SUBJECT: Calvert Cliffs Nuclear Power Plant
Unit Nos. 1 & 2; Docket Nos. 50-317 & 50-318
Response to Requests for Additional Information for the Emergency Core
Cooling System Surveillance Requirement Change

RESPONSE TO REQUEST FOR ADDITIONAL INFORMATION

Mechanical and Civil Engineering Branch

UNIT 2
CCI STRAINER LAYOUT
REDLINE DRAWING

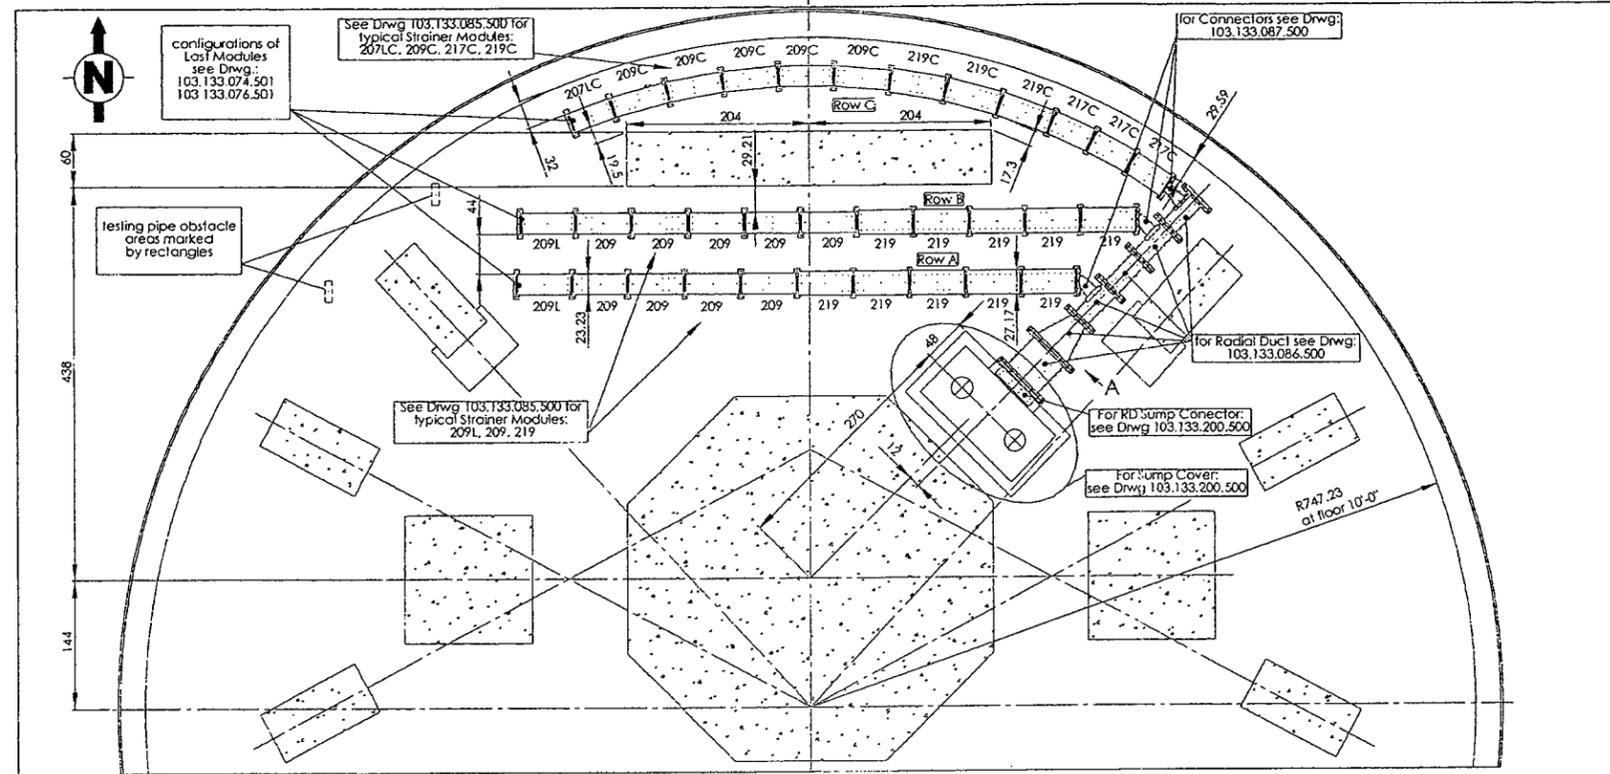
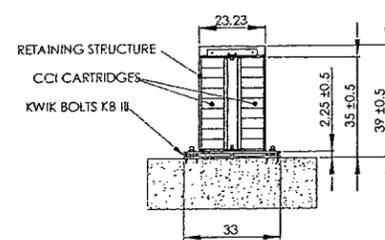
Provide Information showing the layout of the new strainer arrangement and its support system.

See Enclosure (1), which provides a drawing showing the strainer layout and a drawing of the strainer module anchor system.
